Proposed EVM text for 156.9.10

IEEE P802.3cw Task Force, 23 August 2021

EVM Ad Hoc

156.9.10 Error vector magnitude (EVM)

156.9.10.1 EVM conformance test setup

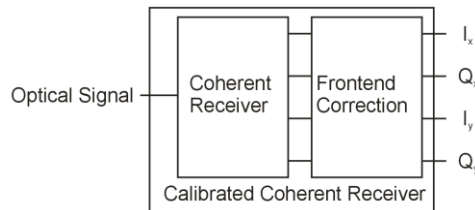
A block diagram for the EVM conformance test is shown in figure 156-7. Connect the 400 Gb/s DP-16QAM transmitter and calibrated coherent receiver using a single-mode fiber patch cord between 2 m and 5 m in length. The conformance test setup consists of the functional blocks described in 156.9.10.1.1 through 156.9.10.1.8. *Add text clarifying nature of EVM reference receiver.*

156.9.10.1.1 Calibrated Coherent Receiver

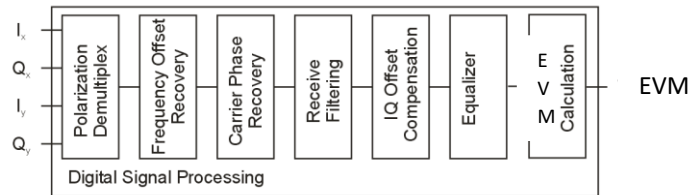
The coherent receiver generates four digitized data streams representing the baseband of two orthogonal polarizations of the optical input signal. The frontend correction removes impairments of the realized hardware implementation of the coherent receiver. *The coherent receiver should have a bandwidth of at least xxx GHz. The ENOB and sampling rate of the digitizers should be at least xxx bits and xxx(1) times the symbol rate. (to be discussed).*
